# SAN FRANCISCO PLANNING DEPARTMENT

## Preliminary Project Assessment

*Date:* June 10, 2014  
*Case No.:* 2014.0562U  
*Project Address:* 469 Eddy Street  
*Block/Lot:* 0337/014A  
*Zoning:* RC-4 (Residential – Commercial, High Density) Use District  
North of Market Residential Special Use District  
80-T Height and Bulk District  
*Area Plan:* None  
*Project Sponsor:* Sean Sullivan, JS Sullivan Development, LLC  
415-206-1758  
*Staff Contact:* Kansai Uchida – 415-575-9048  
[kansai.uchida@sfgov.org](mailto:kansai.uchida@sfgov.org)

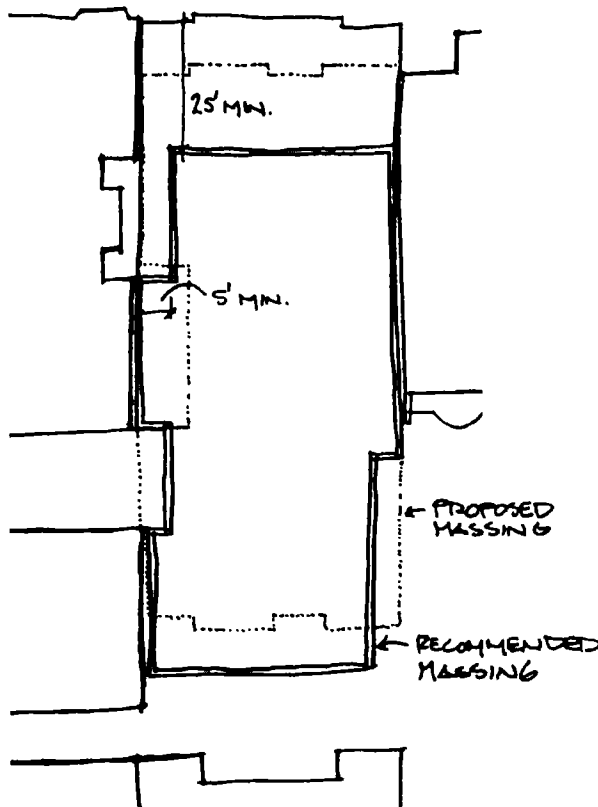
1. **Site Design, Open Space, and Massing.** The Planning Department recommends adjusting the massing of the project 1) to create a better relationship between it and the existing building as well as other buildings on the street frontage, and 2) to better respond to and accommodate the relationships between the building massing and open spaces at the rear, light well, and setbacks

The Planning Department recommends better integrating and preserving the existing historic resource to be more fundamentally a part of the project by setting the addition back a minimum 25'. The interior of the new structure should appropriately reuse or relate to the retained portion of the existing resource.

Re-configure the plan to minimize units that do not meet the exposure requirements.

Match the adjacent light well on the west side of the property to bring the west side of the property in a minimum of 5' to match the adjacent lightwell.

Additionally, the project should create a lightwell or notch at the back open notch of the westside property and could also create a reciprocal notch at the open space to the east. The Planning Department would support the rear wall moving back as long as exposure requirements are met either there or with the adjacent open space on the east side.

This plan diagram should help clarify the intent.

Title: 469 Eddy Street - PPA Shadow Fan  
 Comments: 2014.0562U  
 0337/014A  
 Printed: 30 April, 2014

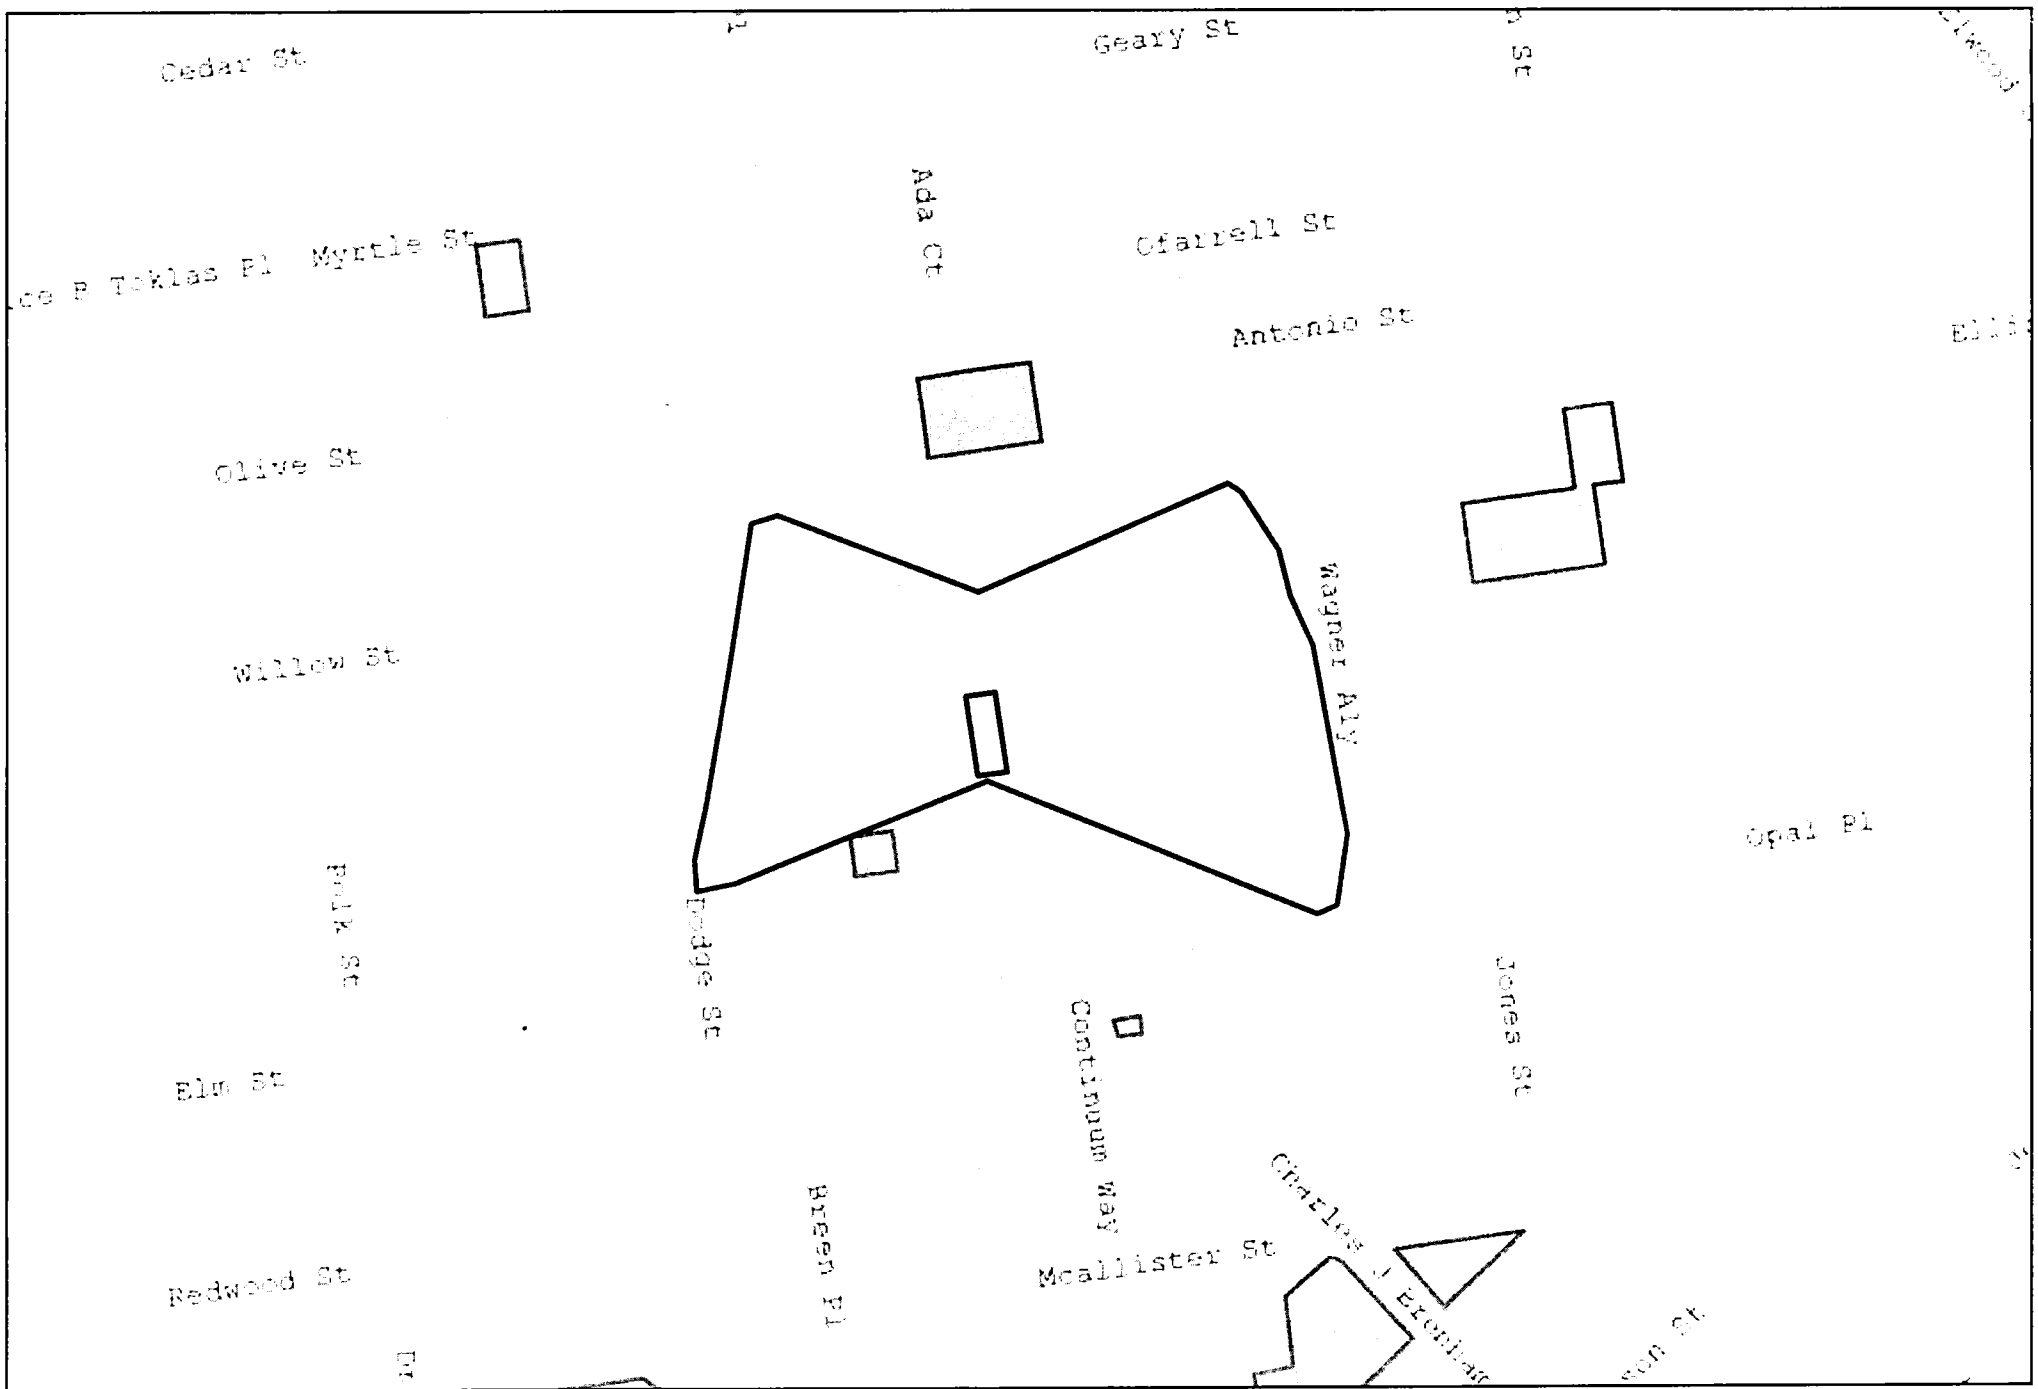
- Show the number of Class 2 bicycle parking required by code.
  - Consider moving all bike parking to ground level.
6. **Shadow Study.** The proposed project would result in construction of a building 40 feet or greater in height. Staff has prepared a preliminary shadow fan analysis that indicates potential shadow impacts from the project to the northern portion of the Turk and Hyde Mini Park (see the enclosed PPA Shadow Analysis). The project therefore would require a shadow study. The project sponsor would be required to hire a qualified consultant to prepare a detailed shadow study. The consultant would be required to prepare a proposed scope of work for review and approval by the Environmental Planning case manager prior to preparing the analysis.

3. A **Shadow Study Application** per Planning Code Section 295 is required for the project, as the proposed building exceeds 40 feet in height. Staff has prepared a preliminary shadow fan analysis that indicates potential shadow impacts from the project to the northern portion of the Turk and Hyde Mini Park (see the enclosed PPA Shadow Analysis). However, this shadow fan does not account for the presence of intervening buildings. The location of the project in relation to intervening buildings would suggest that any potential shadow on the Turk and Hyde Mini Park would be blocked by intervening buildings, or subsumed by shadows cast by other buildings in the area. To determine the extent of potential shadow impacts, a detailed shadow analysis would need to be prepared to determine if the project would create new shadow that results in an adverse impact to the Turk and Hyde Mini Park, pursuant to Section 295. If the project would create new shadow in a manner that substantially affects property under the jurisdiction of the Recreation and Parks Commission, a joint hearing between the Recreation and Parks Commission and Planning Commission would be required.
